PUBLIC UTILITIES COMMISSION

EA2024-1244

SUBJECT: Electric Distribution Audit of PG&E's Kern Division

**PG&E KERN DIVISION
ELECTRIC DISTRIBUTION AUDIT FINDINGS
NOVEMBER 18-22, 2024**

Figure 2: Guy slack limit, TD-2305M-JA02

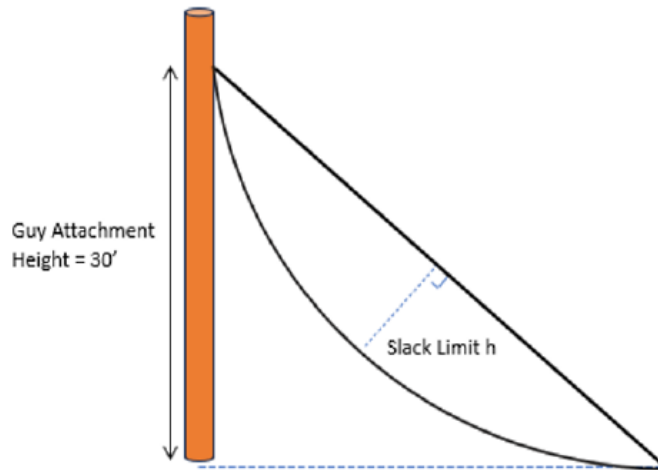
PG&E’s TD-2305M-JA02, Job Aid: Overhead Assessment, March 25, 2024 Rev. 13, Miscellaneous Other Compelling Abnormal Conditions, Guy Broken/Slack/Corroded states, *“Pole must be straight with Guy no more than an arm’s length (3ft) from taut, that does not have significant impact on the structural integrity of the pole.”* See Figure 2.

Per GO 95, Rule 56.2, guys are to be maintained taut.²⁶ PG&E’s TD-2305M-JA02 allows a deviation from taut by as much as 3 feet without regard to length or angle of attachment.²⁷

PG&E’s TD-2305M-JA02, Job Aid, Miscellaneous Other Compelling Abnormal Conditions, Guy Broken/Slack/Corroded does not comply with GO 95, Rule 56.2 requiring guys to be maintained taut in all circumstances.
